Subject: Transportation Consulting Services
Proposed The Sanctuary at Ashland Mills (40B)
10-60 Main Street, Ashland, MA

MDM Transportation Consultants, Inc. (MDM) is pleased to provide you with the following supplemental transportation review comments for the above-referenced project. These comments have been prepared based on review of Proponent's response memorandum prepared by VAI dated February 27, 2025, project coordination meeting with the Town of Ashland department heads on Wednesday, March 12, 2025 via Zoom, and a review of updated Site plans prepared by Bohler Engineering dated March 12, 2025 as identified below. To facilitate response by Proponent, review items requiring response are noted in ***Bold Italic***.

SU-30

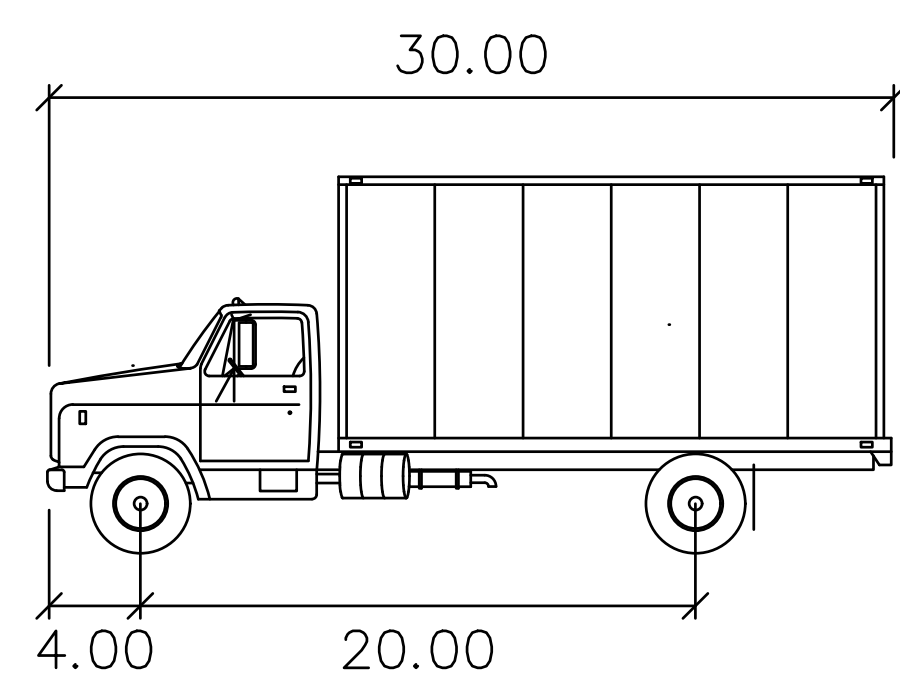
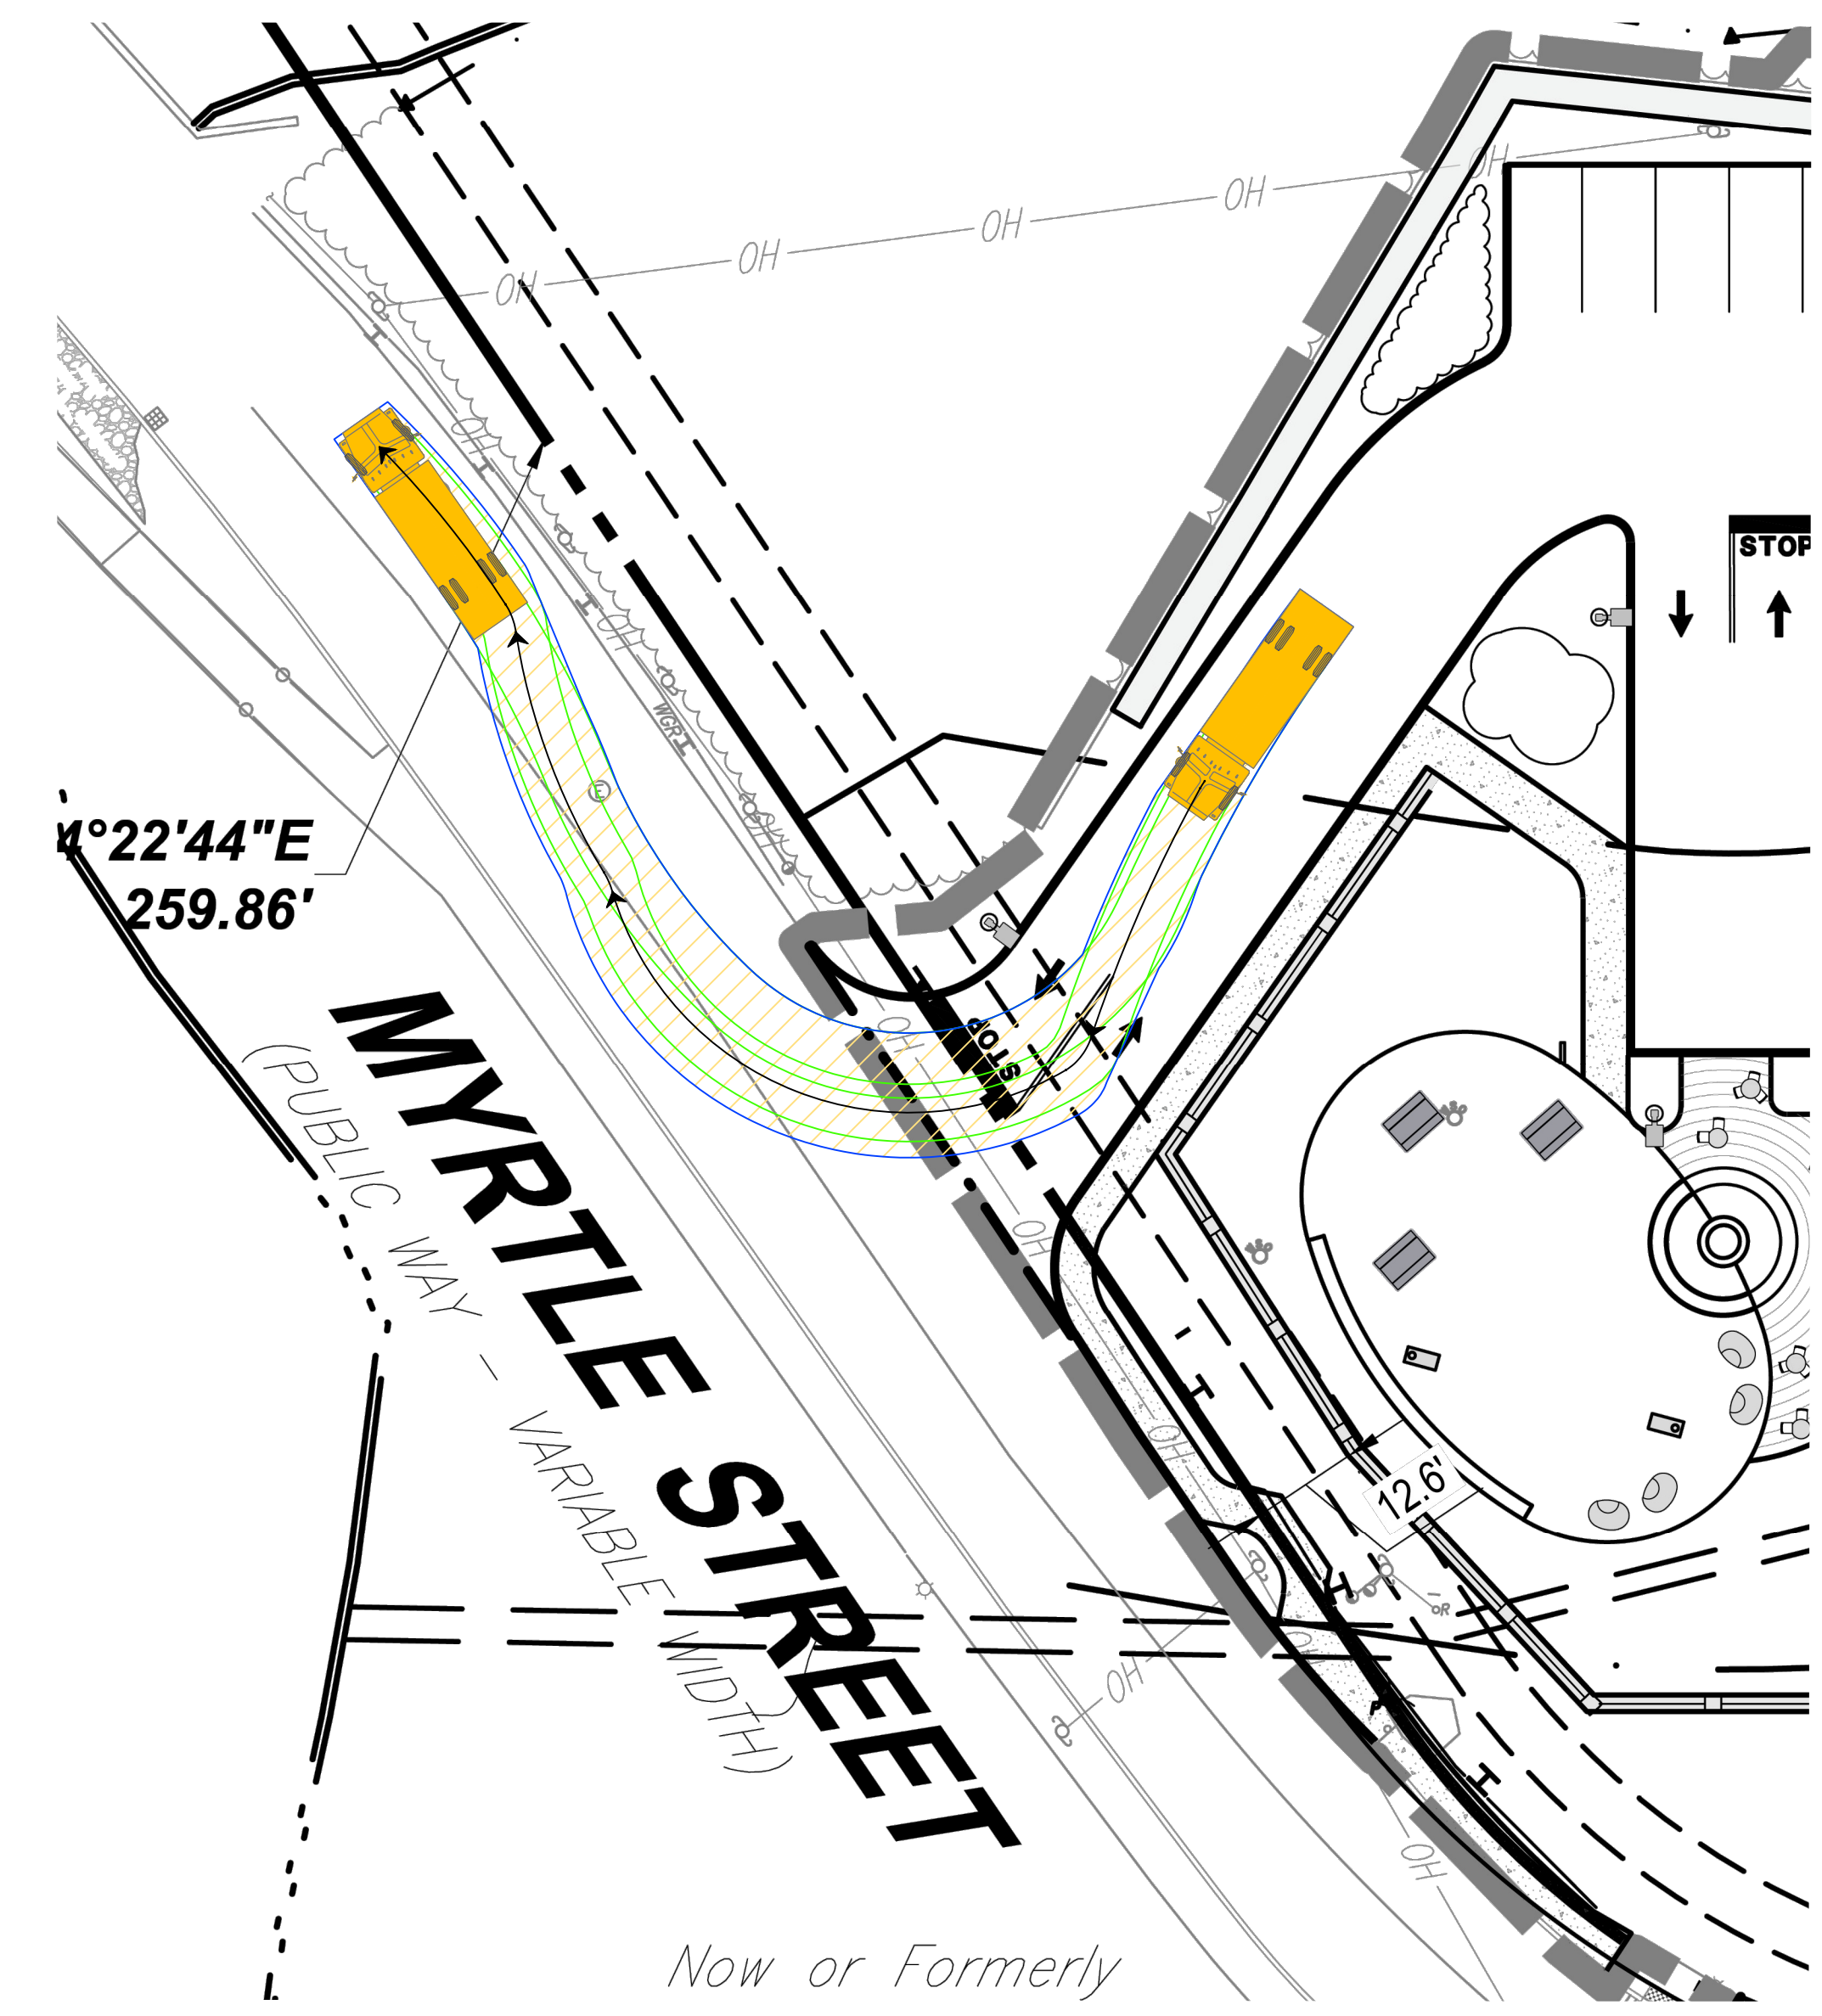
Supplemental Comment: Driveway designs must be modified at the Myrtle Street and Main Street south driveway to eliminate opposing lane encroachments including (in the case of Myrtle Street) encroachment into Myrtle Street southbound lane for right-turn exiting movements.

Supplemental Comment: MDM does not concur that the driveway as proposed meets applicable design requirements for service, delivery, move-in or fire apparatus maneuvering whether these movements occur peak or non-peak. The skewed driveway alignment requires for each of these vehicle types a wide sweep into the opposing travel lane of Myrtle Street or (for entering movements) a wide sweep into the exiting lane of the driveway. This presents a significant safety concern that must be addressed by modifying the driveway alignment and/or adjusting curb radii so that movements do not impact opposing travel. See attached swept path exhibits which illustrate swept paths for various vehicle types based on currently proposed driveway design.
